TECHNICAL REPORT T-79-51

U.S. ARMY
MISSILE
RESEARCH
AND
DEVELOPMENT
COMMAND

PRELIMINARY EVALUATION OF THE FLAT TRAJECTORY PROJECTILE (FTP) CONCEPT

7 May 1979

Figure 1. Vertical accuracy versus range for M72 LAW type projectile with and without FTP lifting surface.

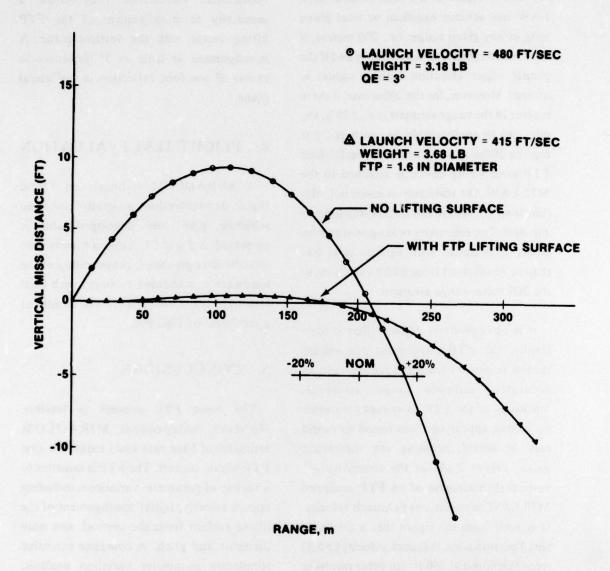
Preliminary MIRADCOM simulation studies indicate the FTP concept is feasible. As seen in Figure 1, the conventional M72 LAW can achieve excellent vertical plane miss at any given range, i.e., 200 meters, if the desired range is known exactly and if the proper super elevation (raised sights) is utilized. However, for the 200m case, if there is error in the range estimate, i.e., $\pm 20\%$, the miss can be considerable, as much as 6-7 ft for the 200m case. When a properly sized FTP nose lifting device is attached to the M72 LAW, the trajectory is essentially flat (less than 1 ft) out to 200 meters, as shown in Figure 1. The sensitivity to range estimation errors is minimal, with vertical miss less than or equal to ±1 ft for ±20% variations in the 200 meter range estimate.

It is obvious from Figure 1 that at least ideally, the FTP attachment can release launch personnel from the requirement to accurately estimate range. However, sensitivity of the FTP to system parameter variations appearing from round to round may be severe, negating any theoretical gains. Figure 2 shows the sensitivity of vertical displacement of an FTP equipped M72 LAW to variations in launch velocity. It is seen from the figure that a relatively small perturbation in launch velocity (± 5%) from the nominal 450 ft/sec value results in ~ 5 ft miss. Figure 3 shows the extreme sensitivity of the miss to the FTP lifting surface diameter. This indicates extensive wind tunnel testing to choose the proper nose diameter (and pitch) to provide just the right amount of lift to cancel gravity drop. Additional simulation runs show a sensitivity to misalignment of the FTP lifting vector with the vertical plane. A misalignment as little as 5° produces in excess of one foot deflection in the lateral plane.

Figure A-3. FTP design concept.

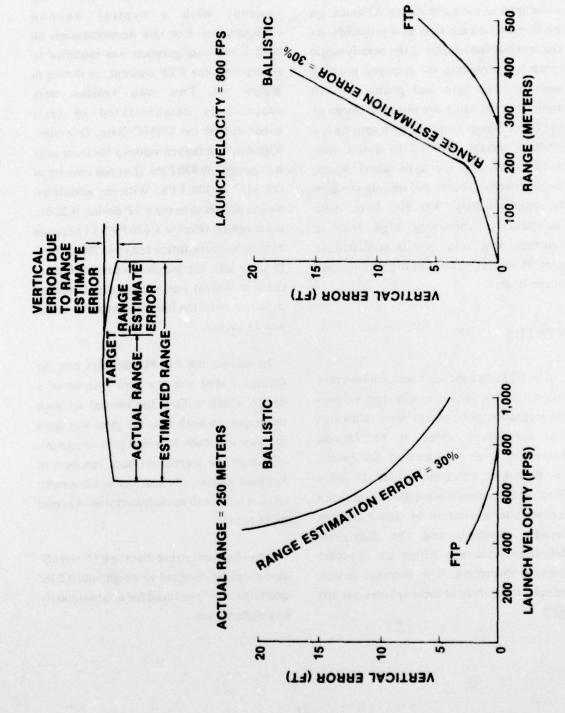
- The concept feasibility rounds fired by the Navy were not performed with the lift mechanism hardware packaged as shown in the FTP design concept sketch (Appendix A, Figure A2). Instead, the gyro, spin-up apparatus, and other parts, were mounted in a special hollow section of the warhead. Thus, no actual hardware mechanism of the FTP concept in the nose-mount retrofit configuration has yet been constructed.
- The NAVY feasibility flights were performed with expensive bearings, etc.

- Off-the-shelf single degree-offreedom TIMEX gyros will meet Navy concept size, and momentum requirements.
- Gyro spin-up mechanism in nosemount retrofit configuration is unclear (Appendix A, Figure A2). Techniques such as launcher mounted gas bottle, doughnut-

shaped gas bottle internal to nose-mounted FTP, etc., may work but are much more complex and expensive than original inertial set-back spin-up technique Navy proposed but could not demonstrate in the field.
